SERVICE BULLETIN CHANGE NOTICE

S.B. No. A320-21-1017 REV.

TITLE : AIR CONDITIONING - AVIONICS VENTILATION - INSTALL A CHECK VALVE
AT AIR INLET.

MODIFICATION No. 21899P1669

Replacement of the Blowing Duct
Figure 1, Sheet 2

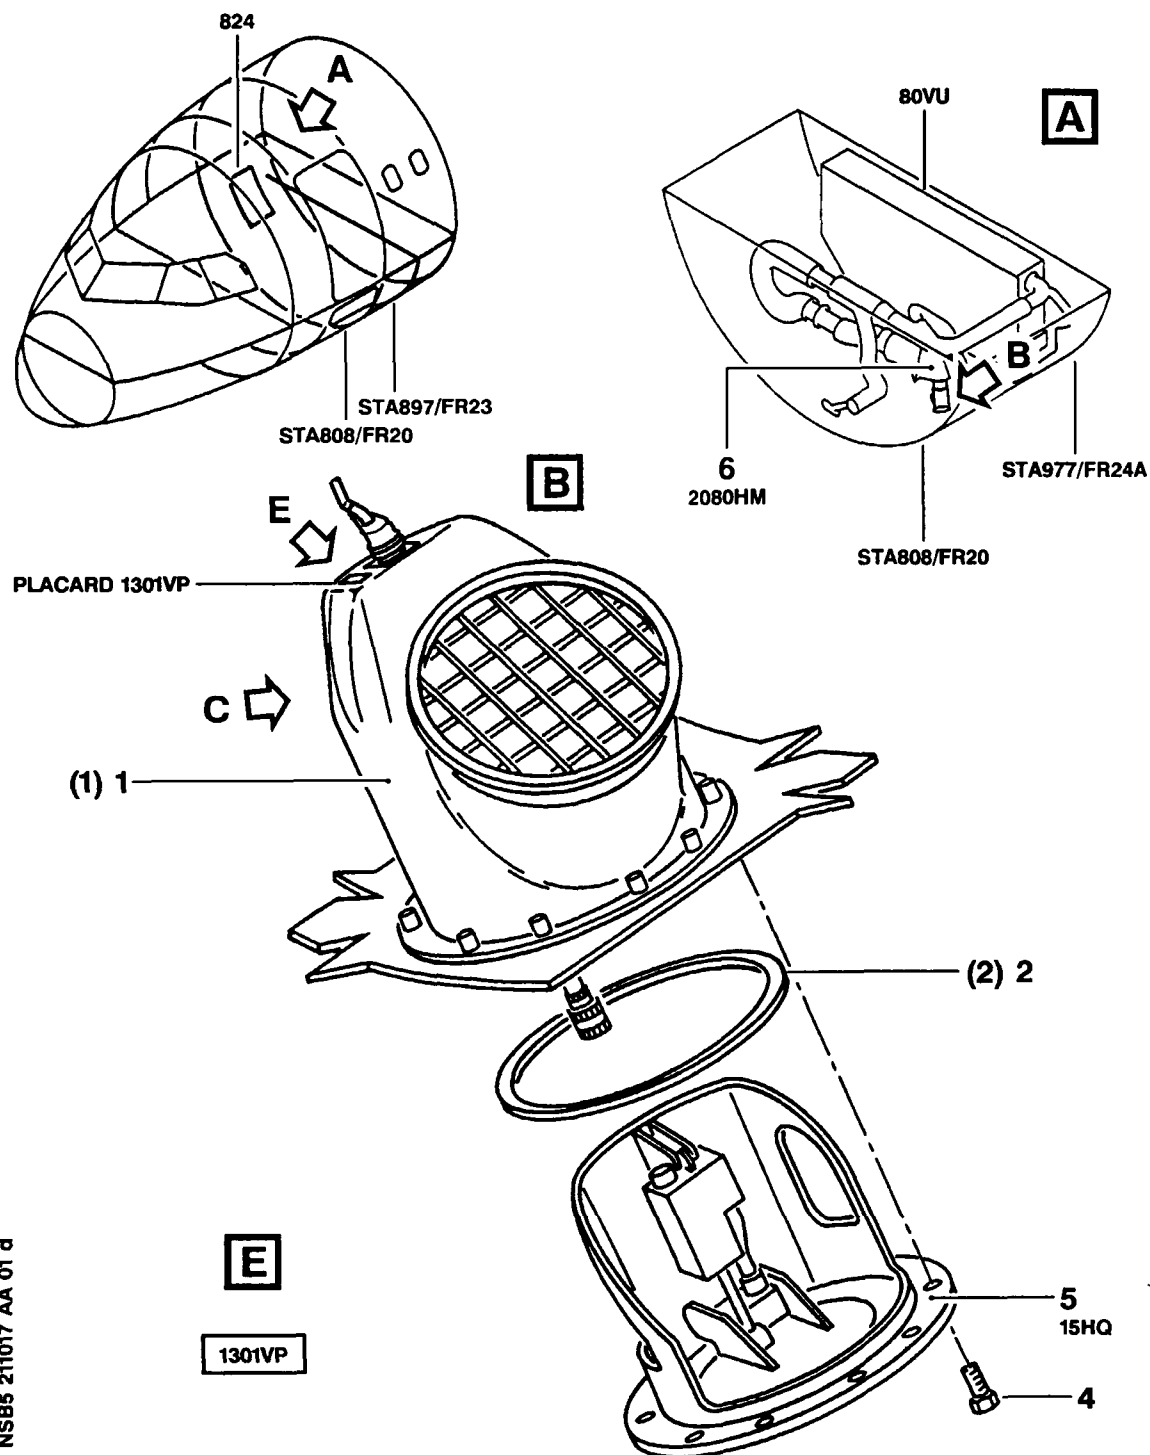
- (d) On Item 1, near the equipment concerned, install :
1 placard identified 1301VP (View on E).

Replacement of the Blowing Duct
Figure 1, Sheet 1 of 2

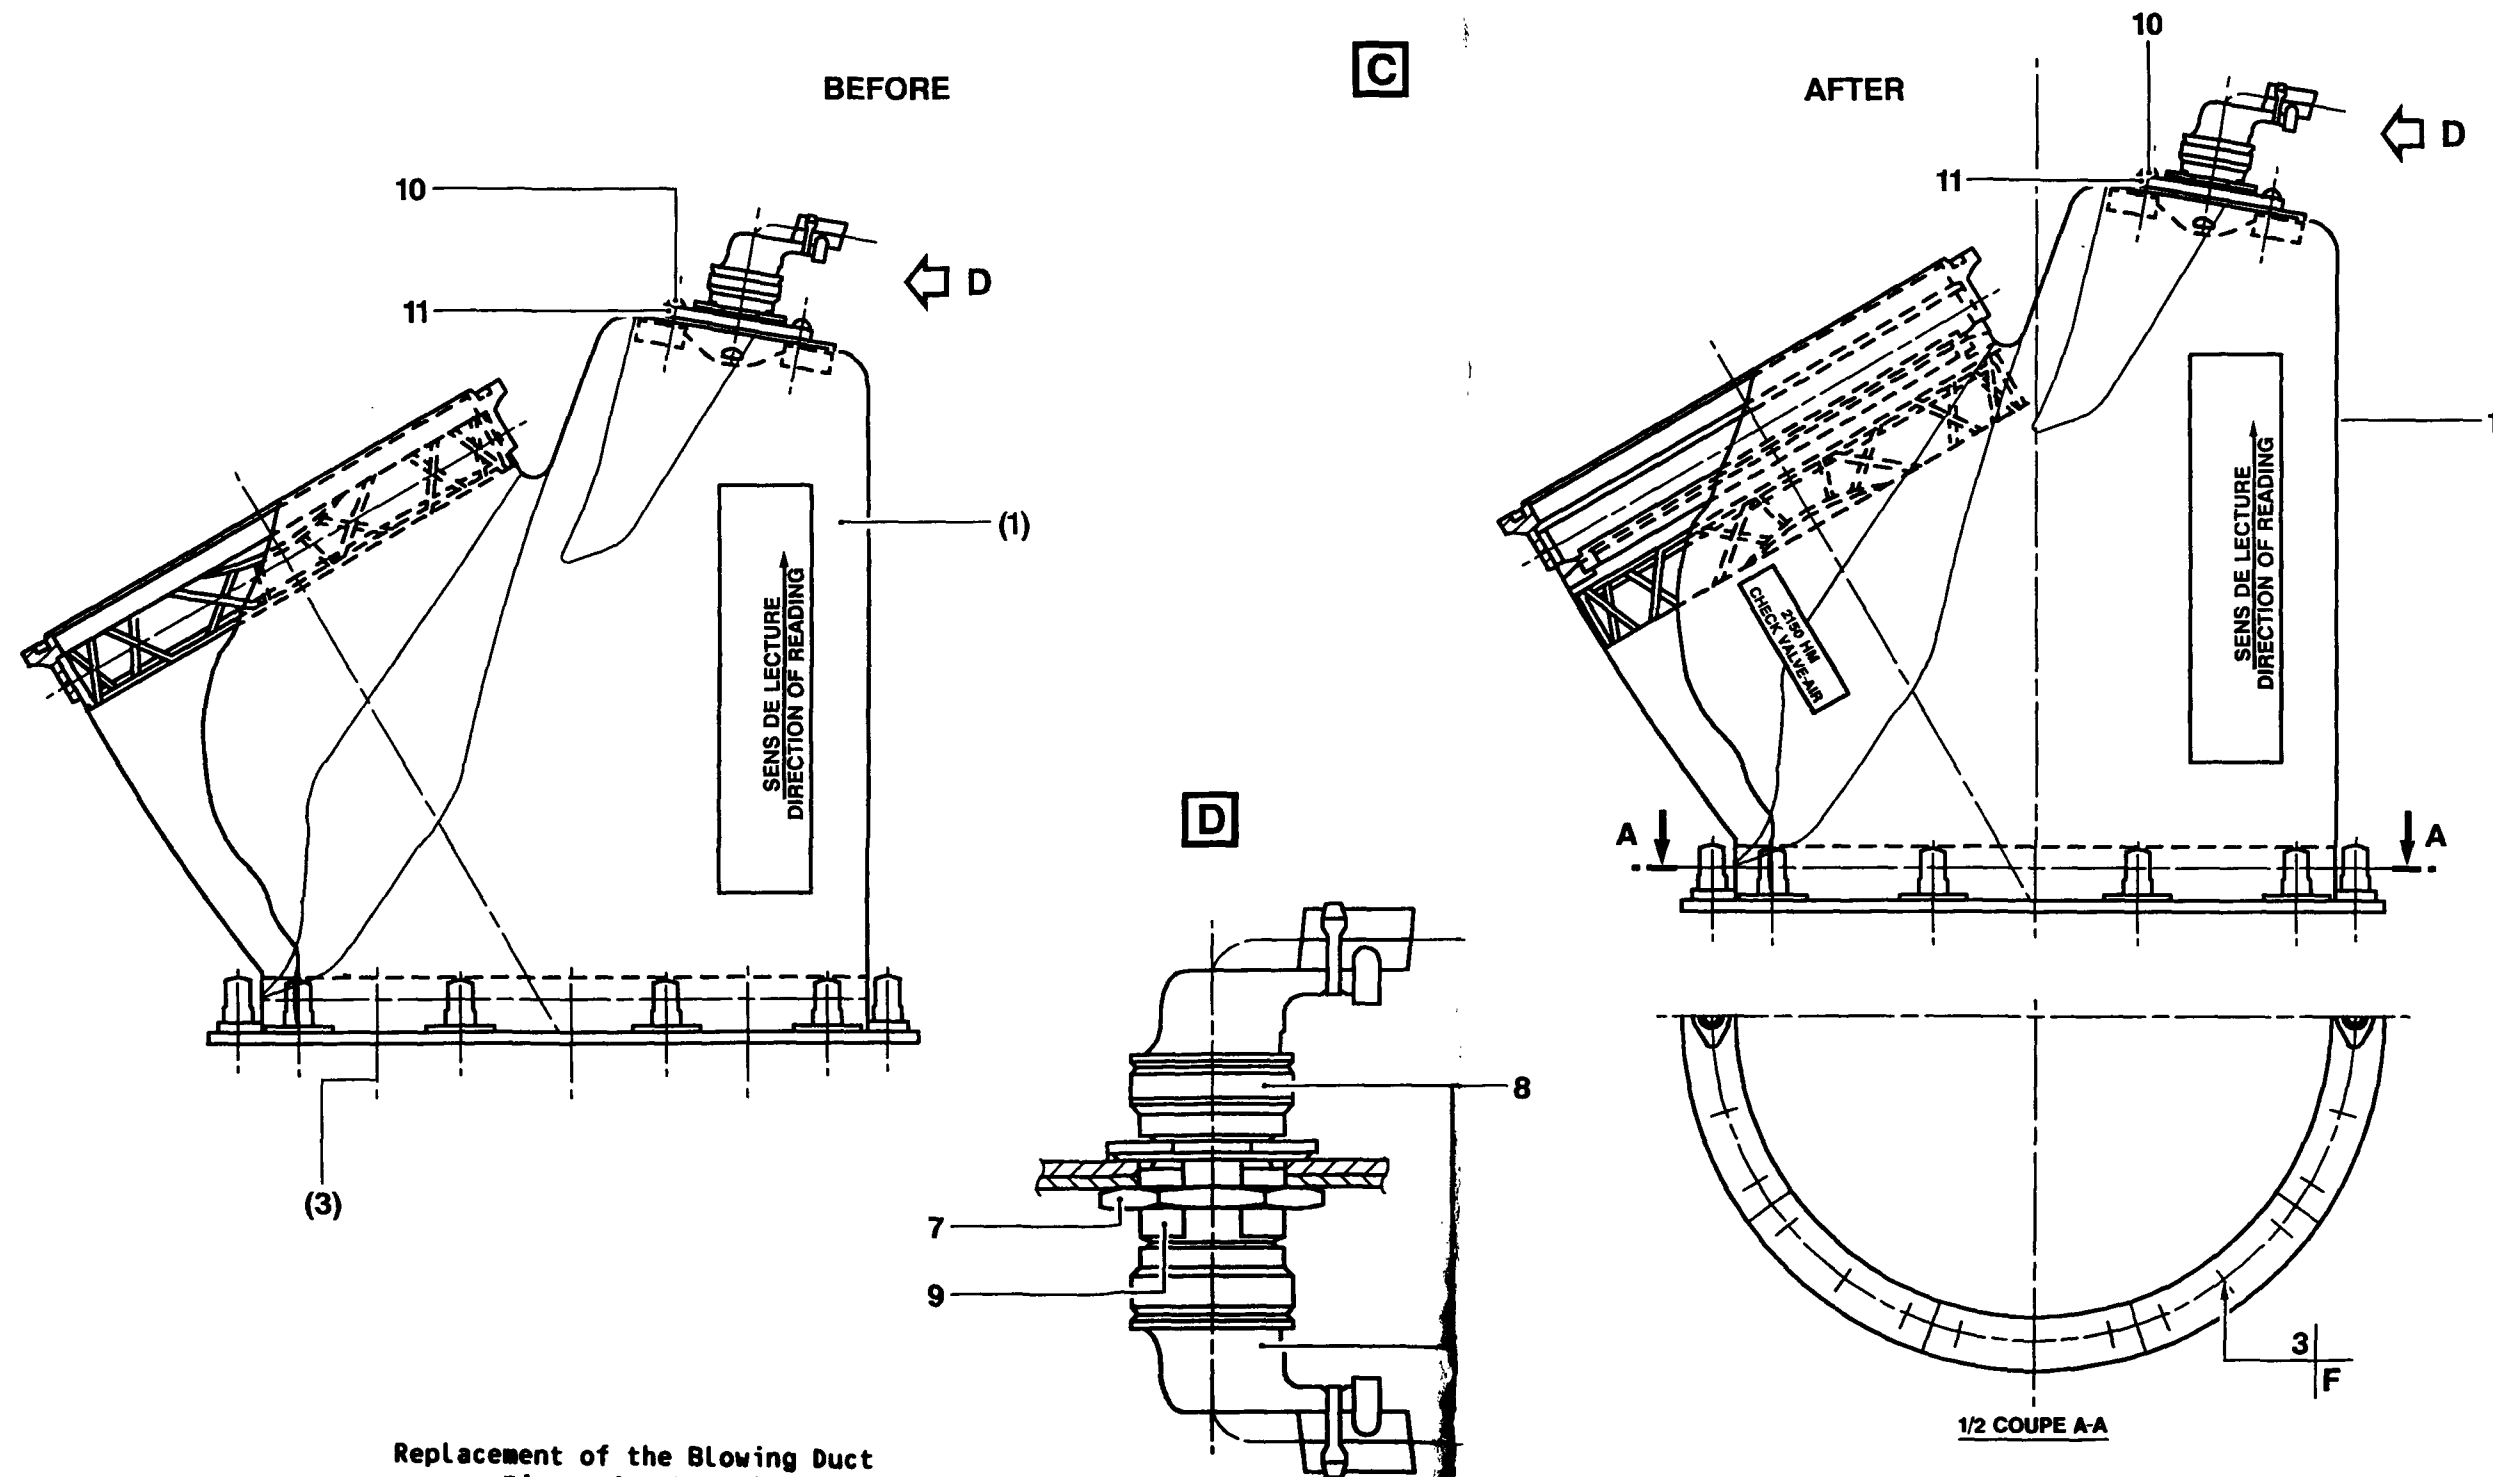
Refer to Figure 1, Sheets 1 of 2 and 2

(1) Remove :

1 demister air inlet 2080HM (Ref. AMM 21-26-43, P. Block 401)	Item 6 (retain)
1 nut	Item 7 (retain)
2 couplings	Item 8 (retain)
1 bulkhead connector	Item 9 (retain)
4 screws	Item 10 (retain)
1 plate	Item 11 (retain)
10 rivets	Item (3) (discard)
1 blowing duct	Item (1) (discard)

(2) Install :

1 blowing duct assy D5391268600295 (equipped with a check valve CT141)	Item 1
---	--------
